UNITED STATES PATENT AND TRADEMARK OFFICE

Office Action Summary	Application No. 10/612,254	Applicant(s) LAMBRIGHT, MICHAEL	
	Examiner Gregory W. Adams	Art Unit 3652

DETAILED ACTION

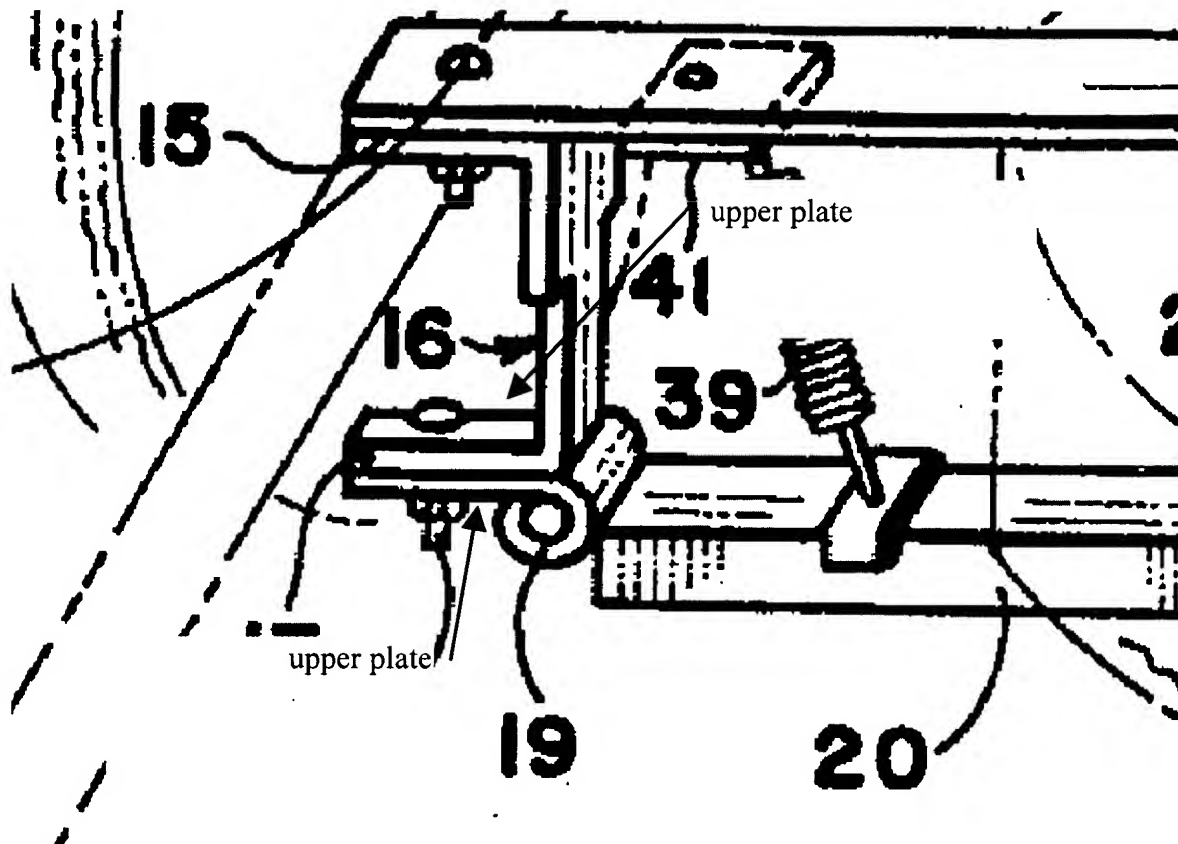
With respect to claims 1 & 9, Krakow discloses a spare tire carrier comprising a support arm 20, 21 having a central axis (indicated generally as 19), latch member, upper and lower planar guide plates (see FIG. 1 reproduced below) having a common axis whereby relative rotational movement of said upper and lower plates pivots a support arm 21 about a upper and lower planar guide plates and rotates about a central axis.
